WATERBURY FILING NO. 1

CONSTRUCTION SET

GRADING AND EROSION CONTROL PLAN

FINAL EROSION CONTROL PLAN 1

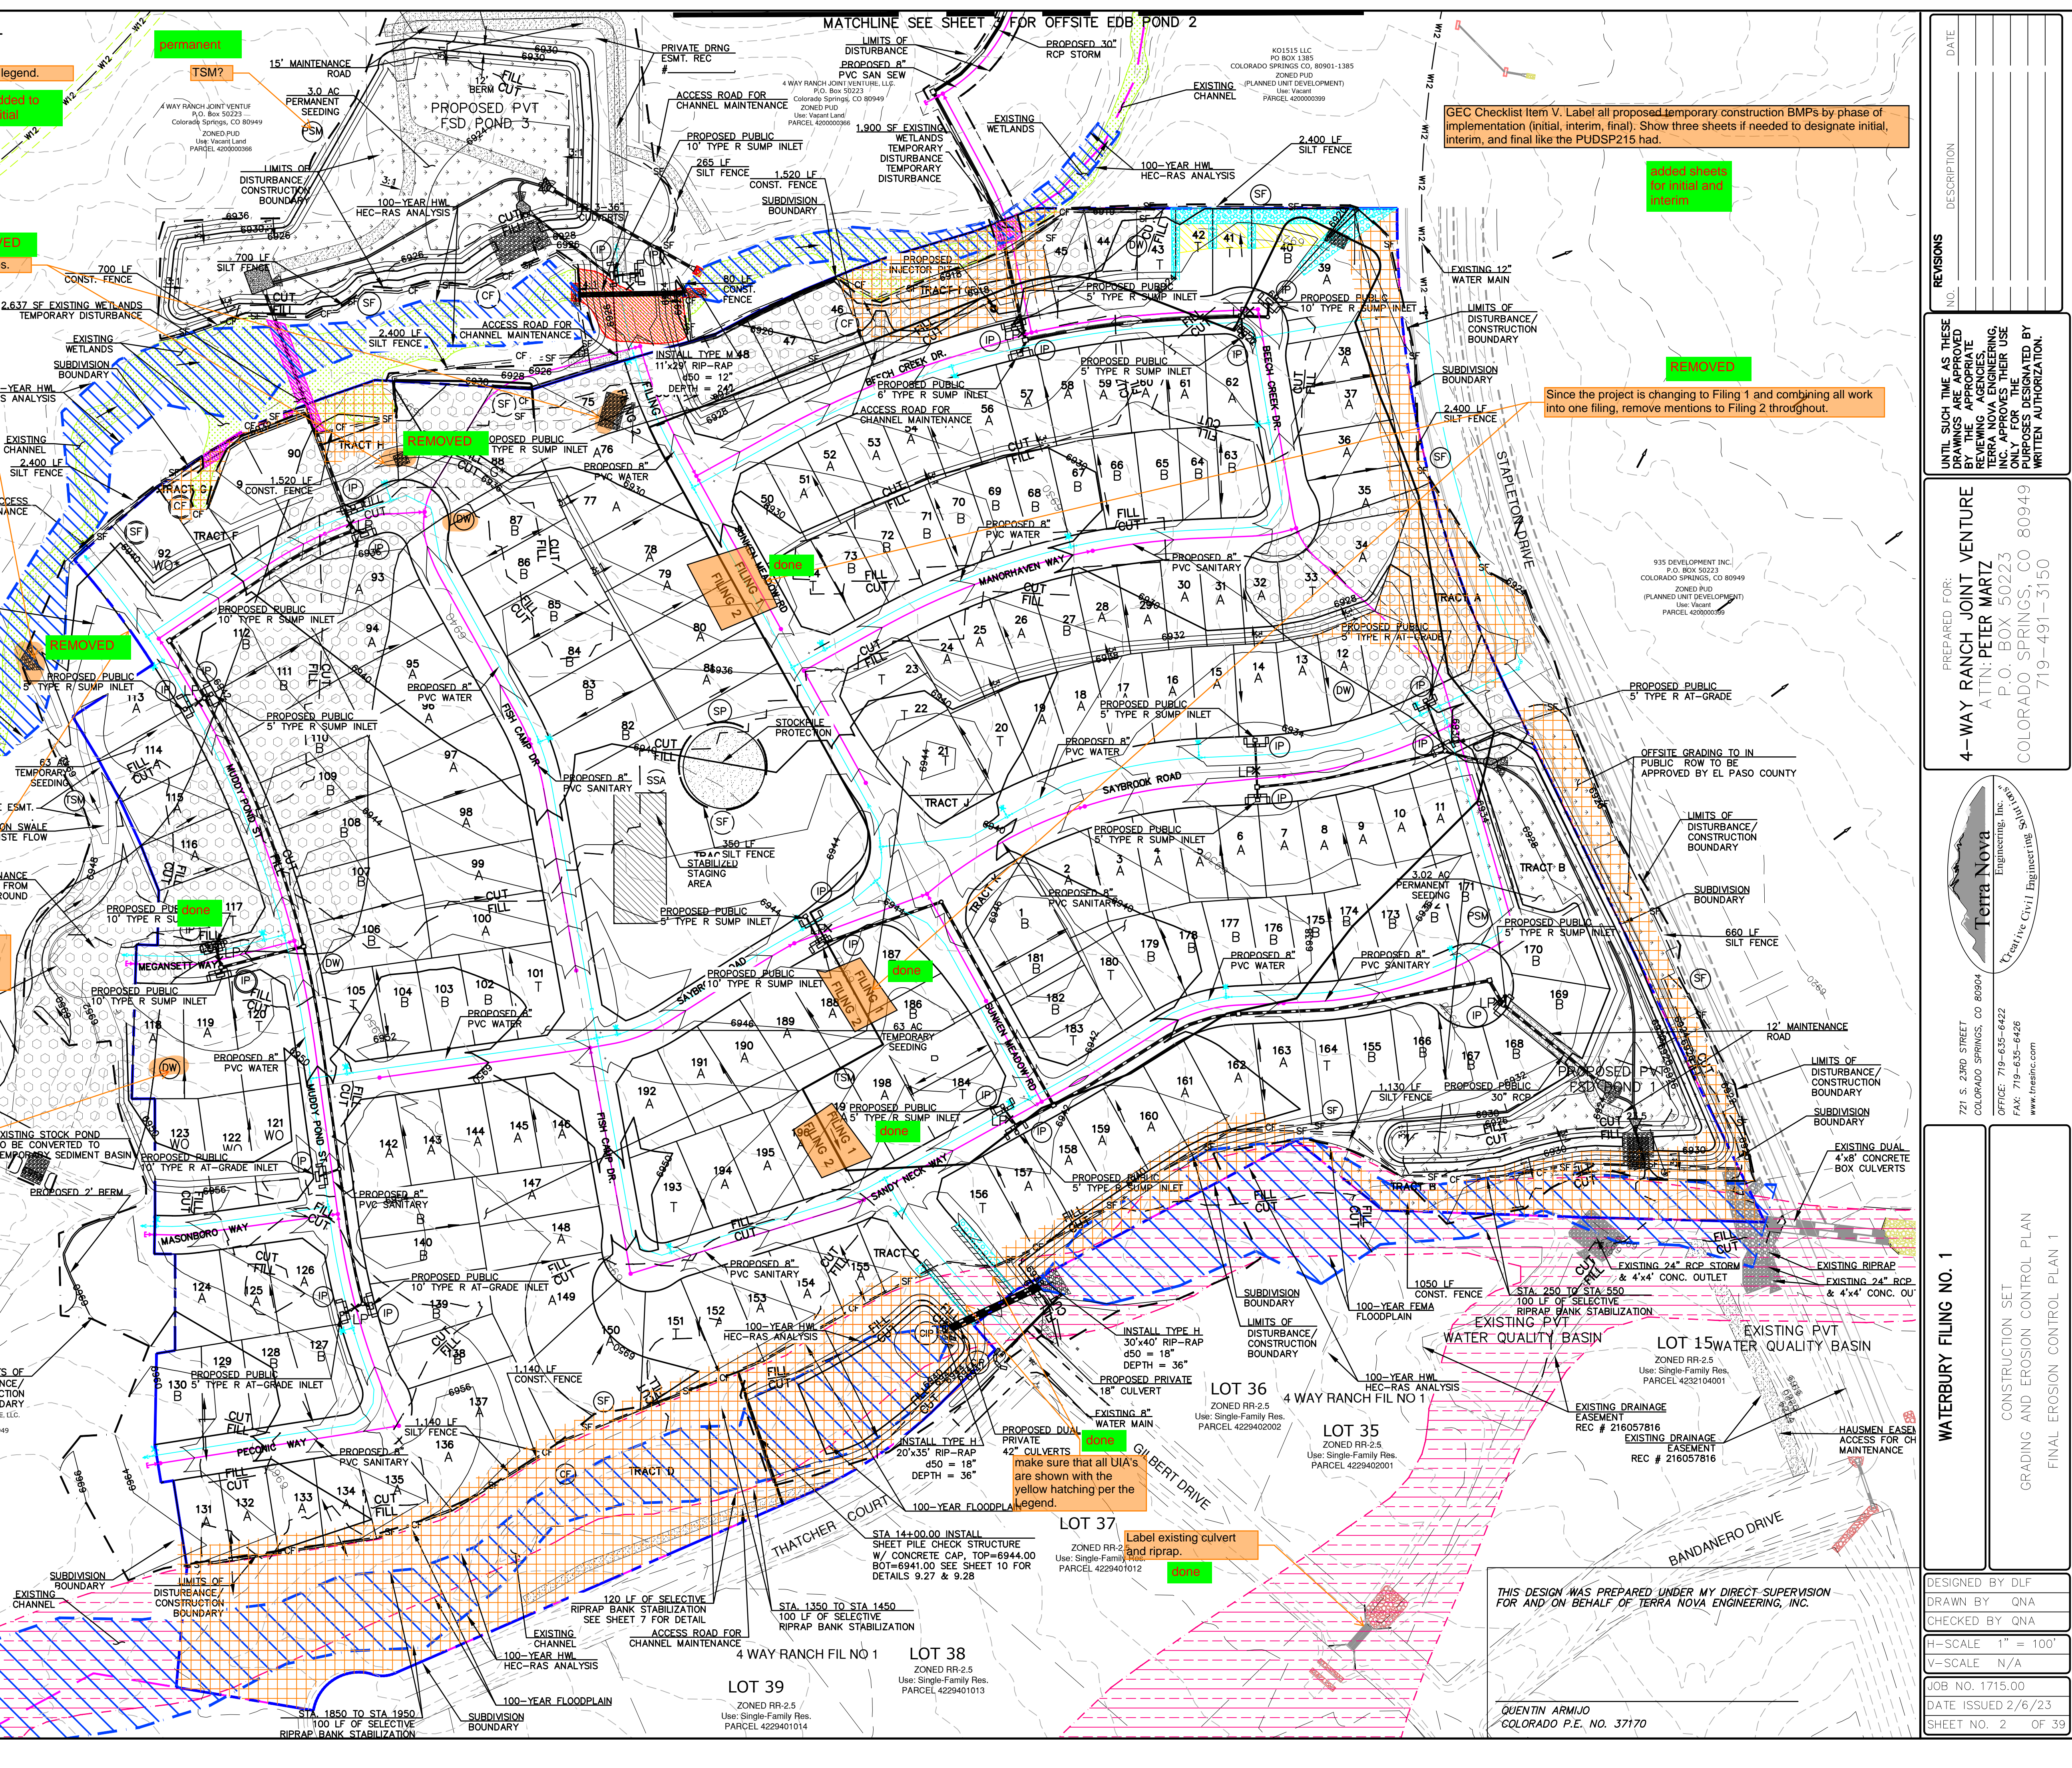
Add a general note: all areas to be vegetated with permanent seeding should also be temporary stabilized via track rolling or some other means.

- Put TSB in legend.
- Define these shapes.
- Put DW in legend and provide detail for if needed.

Put DW in legend and provide detail for if needed.

TYPICAL SECTION - 50' ROW 30' MAT
N.T.S.

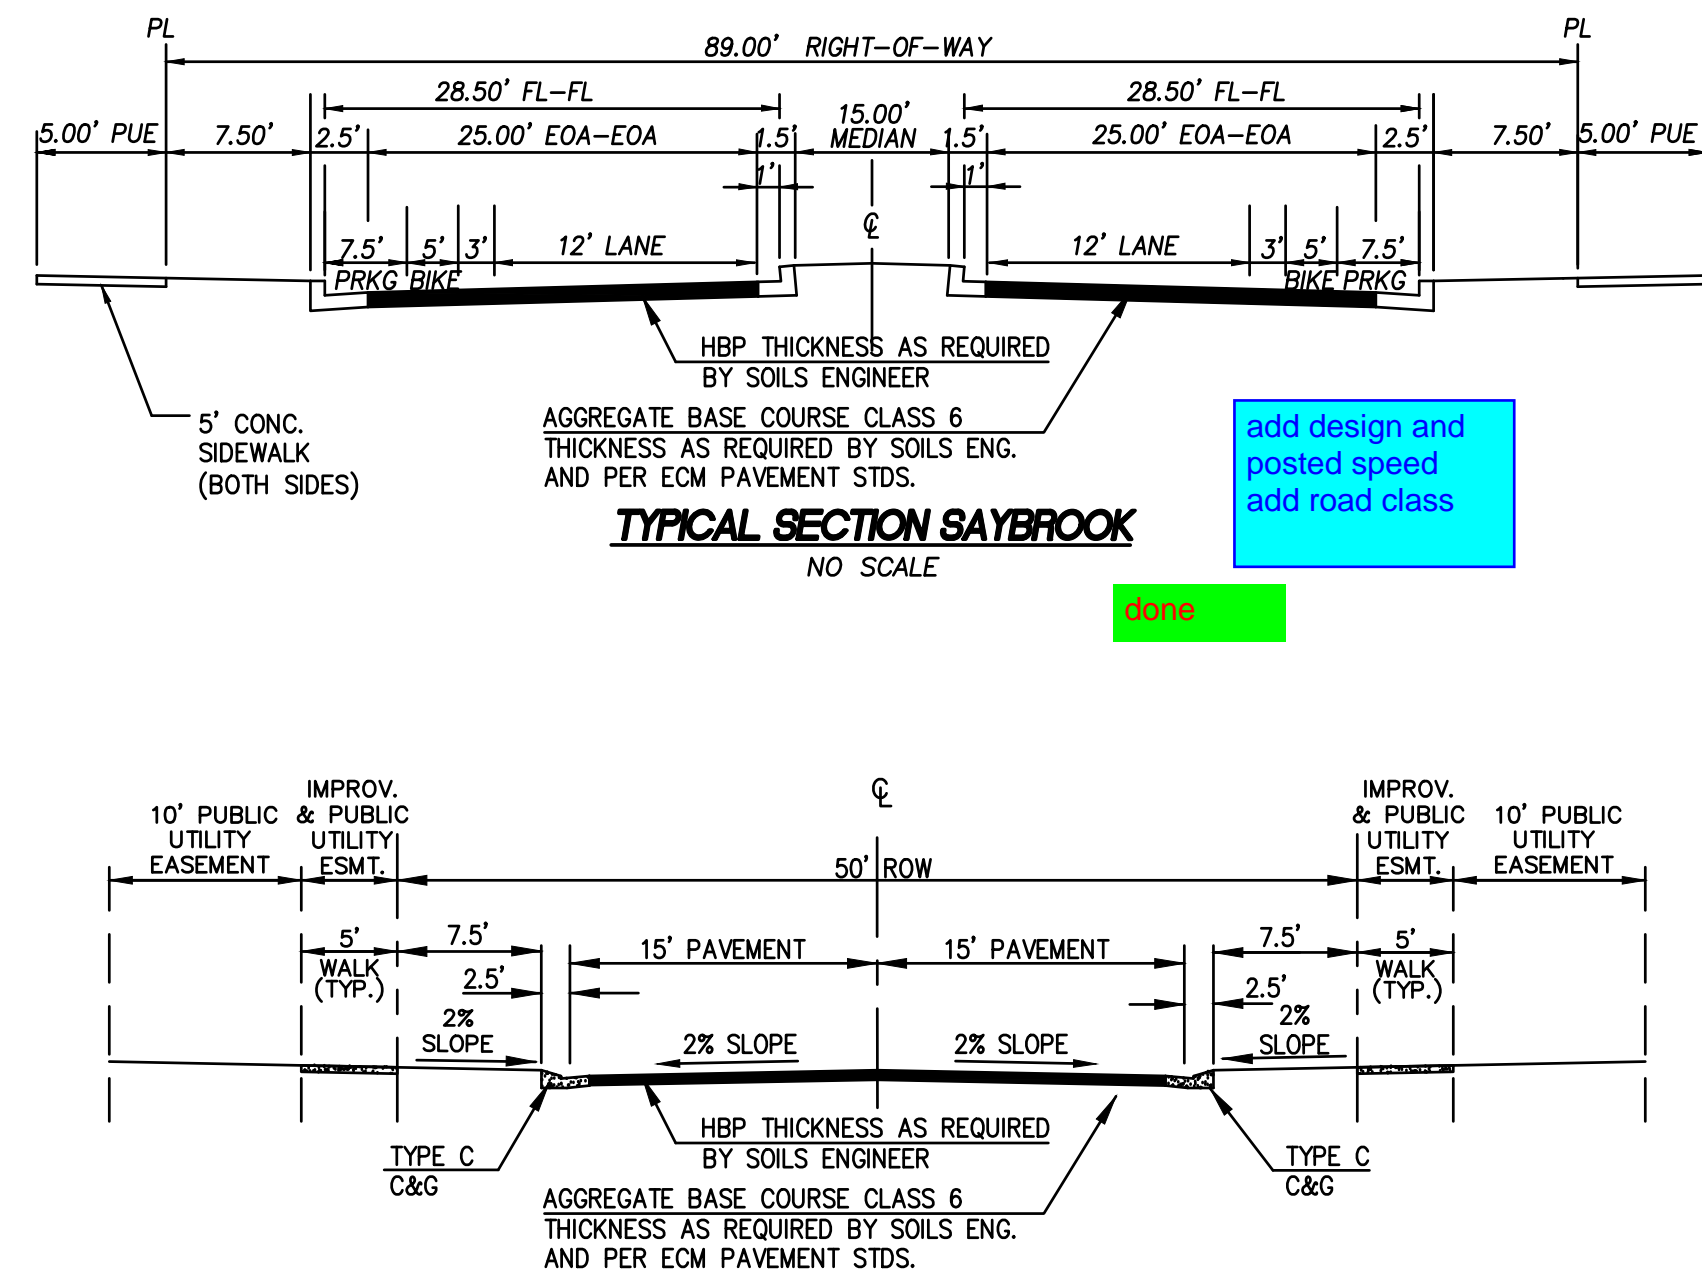
Add details for the construction fence and culvert inlet protection.

Add road class urban
local with street
name(s)

Add road cross section for
Gilbert Rd

Done
